550 #7
3/24/76

SERVICE BULLETIN

SOFT MOUNTING CUSHIONS IMPROVE INSTRUMENT ACCURACY

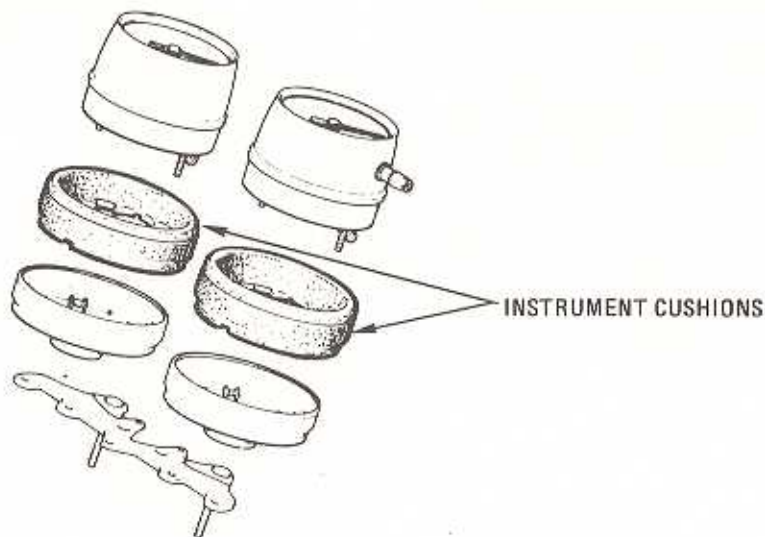
Instrument inaccuracy or needle fluctuation is frequently caused by vibration transmitted through the instrument mounting and does not necessarily involve any defect in the instrument itself.

Softer material is now used in instrument mounting cushions. Soft cushion material causes less vibration to be transmitted to the instruments.

The new, soft instrument cushions are supplied as original equipment on the following CB-550 models:

- CB-550F-76 ————— Frame #2004028 and subsequent
- CB-550K-76 ————— All

Soft instrument cushions are available as replacement parts for use on all earlier CB-550 models.

When you encounter an inaccurate or fluctuating speedometer or tachometer on a CB-550 model not equipped with soft instrument cushions, you may be able to correct the problem by simply installing new cushions.

Do not attempt to correct instrument inaccuracy or needle fluctuation by replacing the instrument, unless the problem persists after soft instrument cushions have been installed.

The part number for the new, soft instrument cushion remains the same as the part number for the previous instrument cushion. Dealers ordering this part number will now receive the new, soft instrument cushion.
